Subject: Nora and Valari Site Plan Review | P-05-26-26-01 | Request for Revisions

MEMO

To: Travis McDonald
From: Nikole Coleman, AICP, Planning Manager
Subject: Nora and Valari Site Plan Review | P-05-26-26-01 | Request for Revisions
Date: July 10, 2026

Engineering Division-Memorandum

ONE-WAY NE SUNSET STREET IMPROVEMENTS
& RIGHT OF WAY DEDICATION

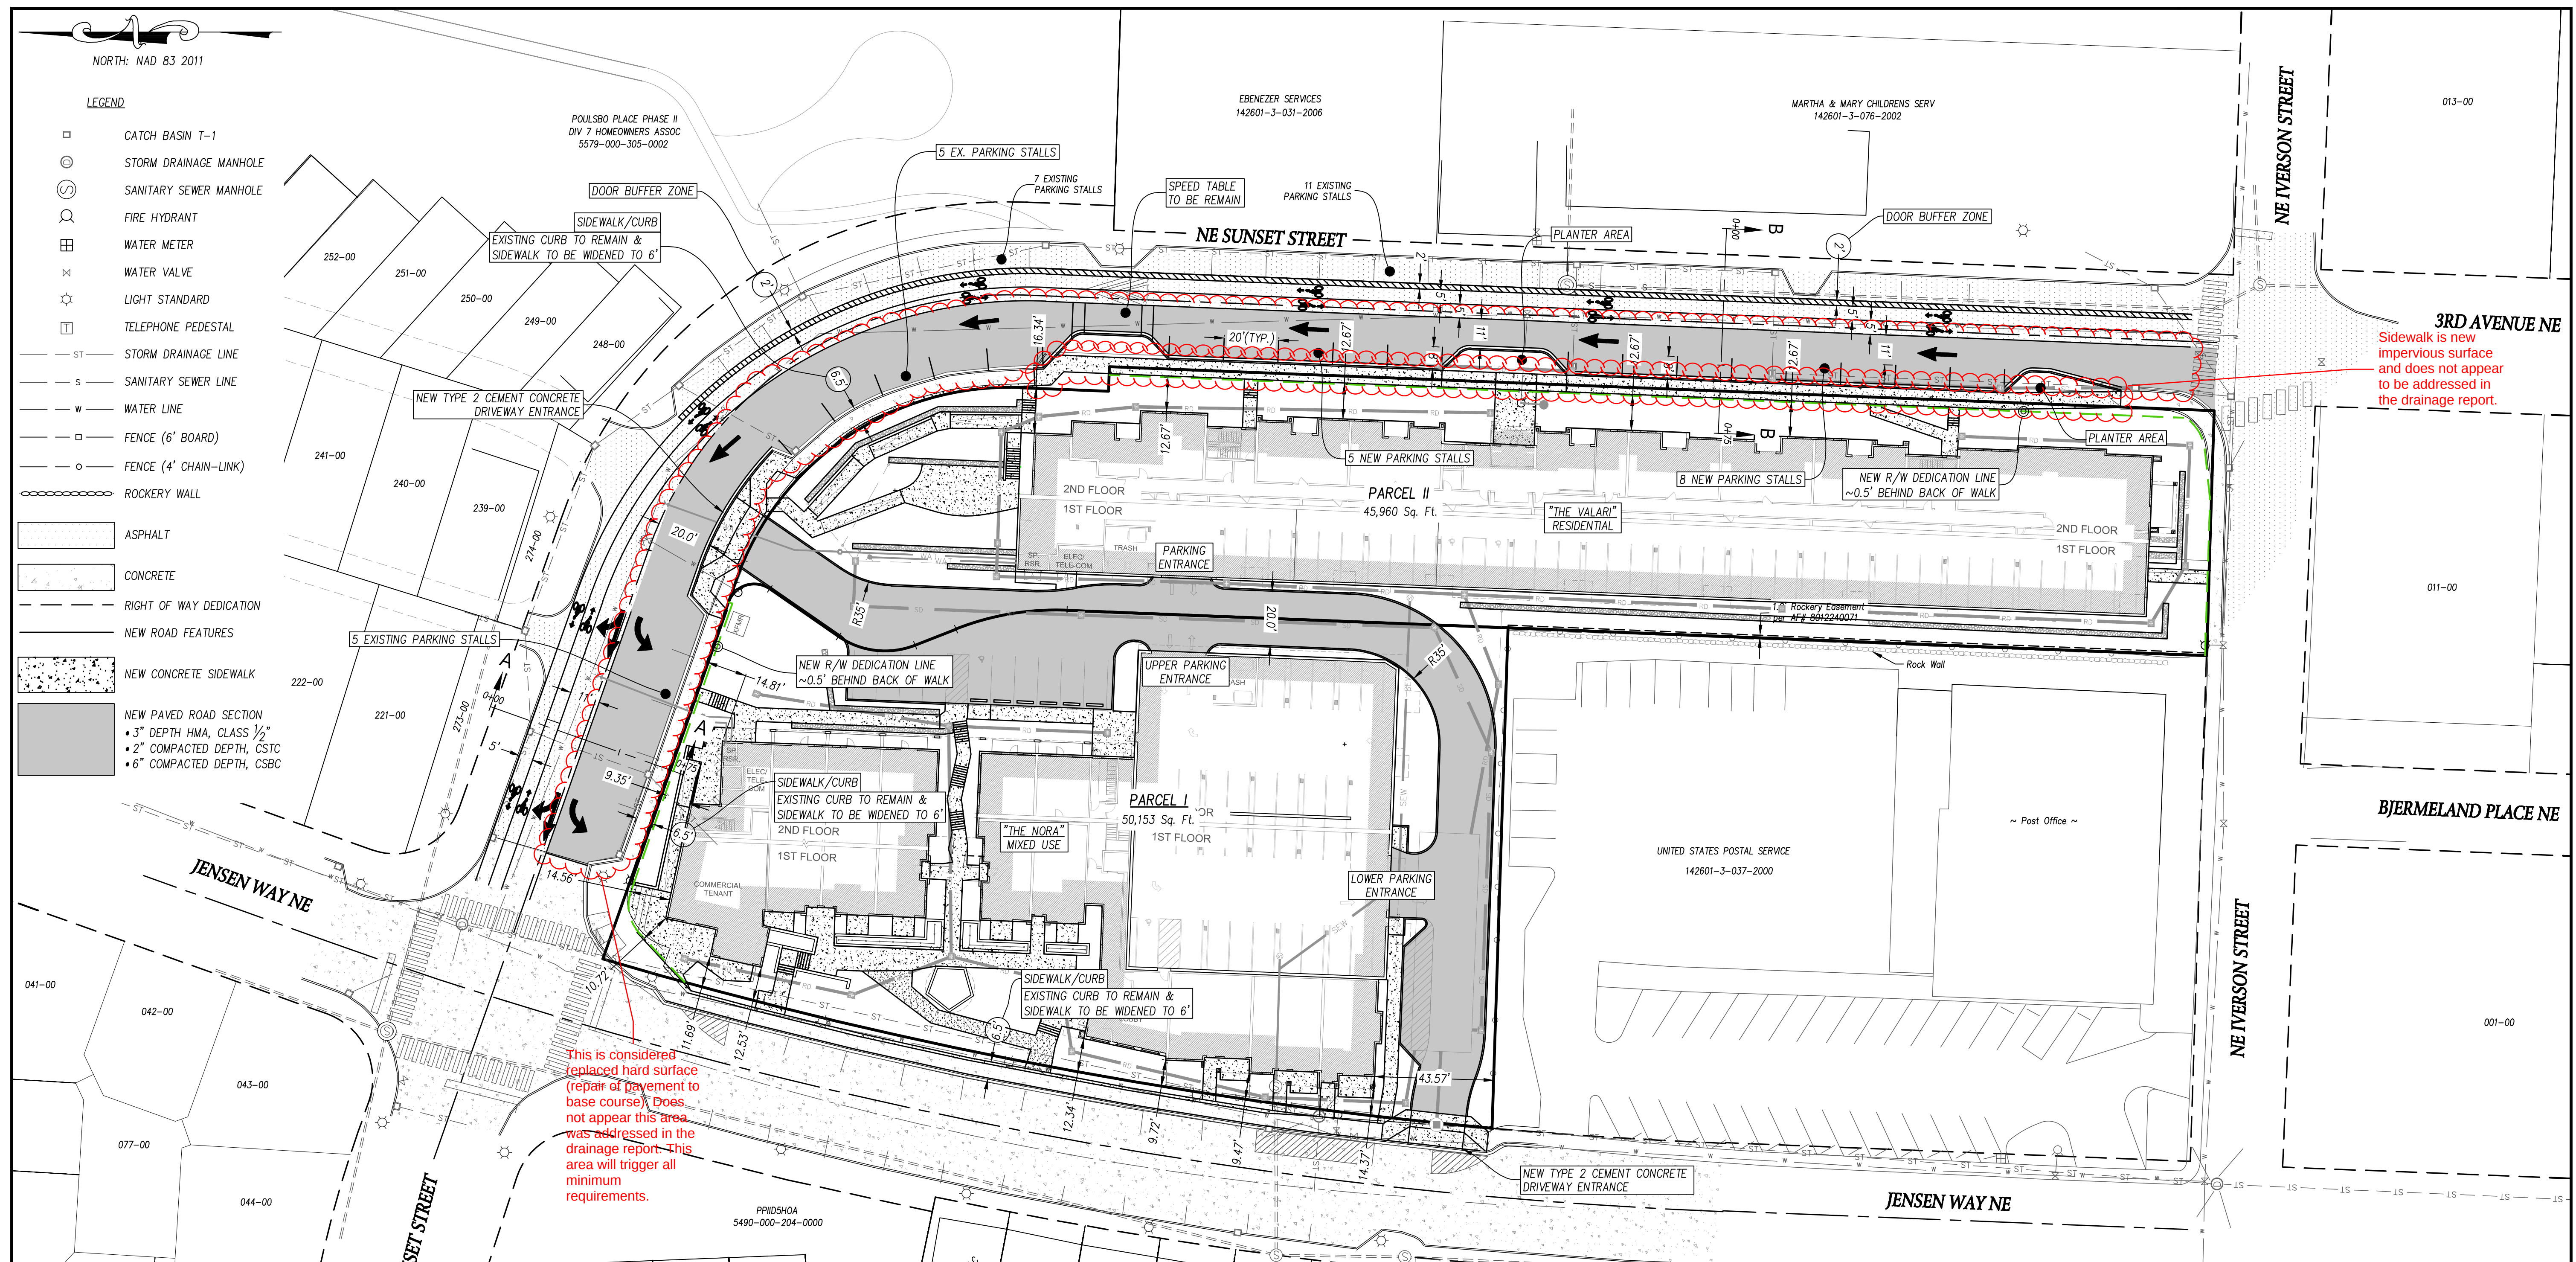
This is considered replaced hard surface (repair of pavement to base course). Does not appear this area was addressed in the drainage report. This area will trigger all minimum requirements.

3RD AVENUE NE
Sidewalk is new impervious surface and does not appear to be addressed in the drainage report.

PRELIMINARY SANITARY SEWER & WATER PLAN

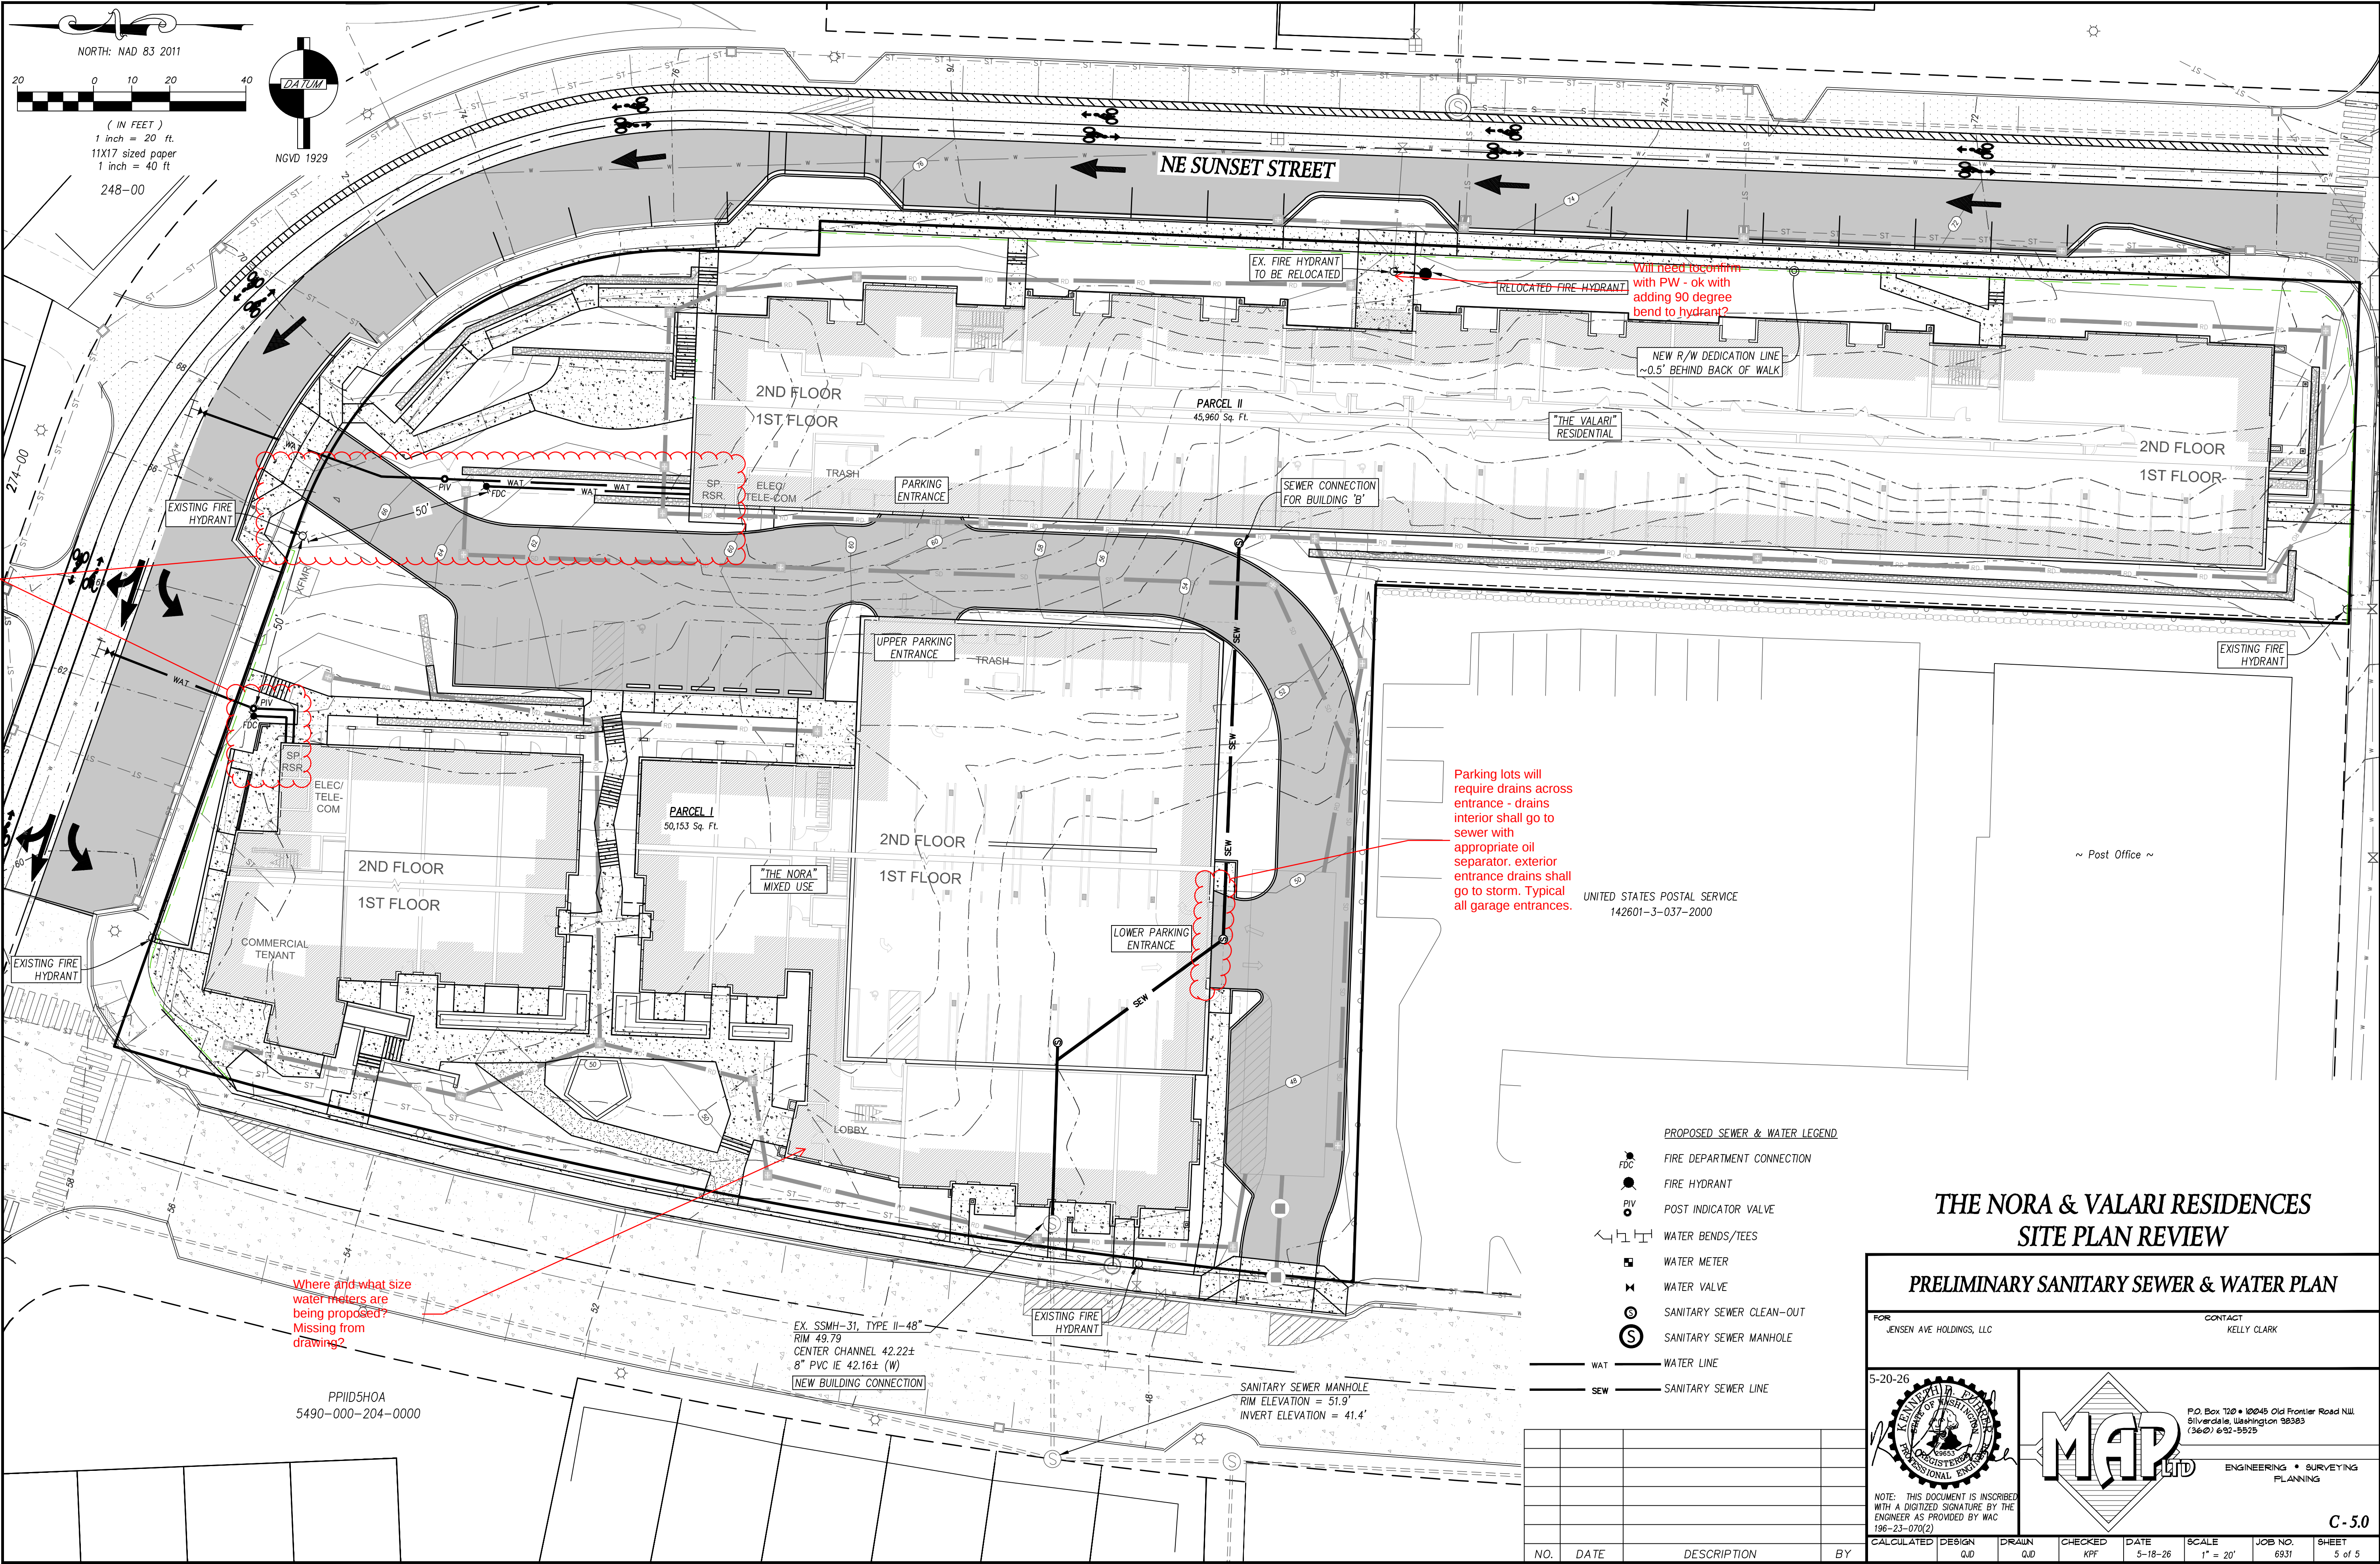
Fire Hydrants must be spaced at no greater than 300' intervals - BR

Fire Hydrant, FDC, and PIV must be located within a 25' radius. The exterior access to the Sprinkler room allows for the removal of the PIV - BR

Where and what size water meters are being proposed? Missing from drawing?

Parking lots will require drains across entrance - drains interior shall go to sewer with appropriate oil separator. exterior entrance drains shall go to storm. Typical all garage entrances.

Will need to confirm with PW - ok with adding 90 degree bend to hydrant?
